## Addendum

**The following sections and figures in this user manual have been updated since this manual was printed.**

*To bring this manual in line with IEC 61993-2 (ed3.0) the following changes have been made.*

**Figure 22** Alert Icons

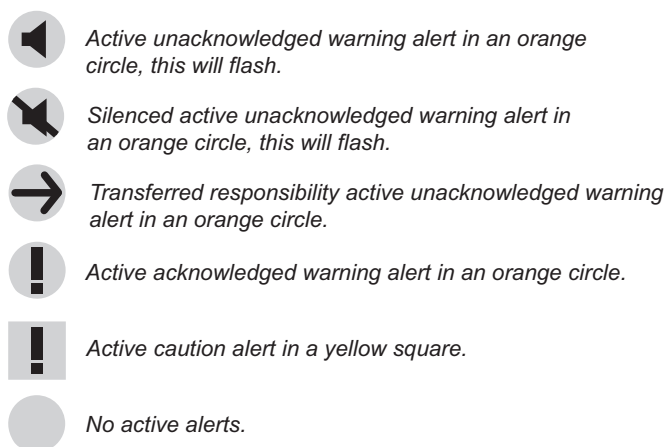
*The Alarms icons on the screen top bar have been changed to new Alerts icons. See section 4.6.7 below for more information on the Alert icons.*

*Section revised and renamed as:*

The Alerts icon indicates the alert status. When there are no active alerts the blank icon is displayed, see Figure 22. If a warning alert occurs, the display changes to show the unacknowledged warning alert icon. Once the warning alert has been acknowledged, the acknowledged warning alert icon is displayed. If the only active alerts are caution alerts, the caution alert icon is displayed.
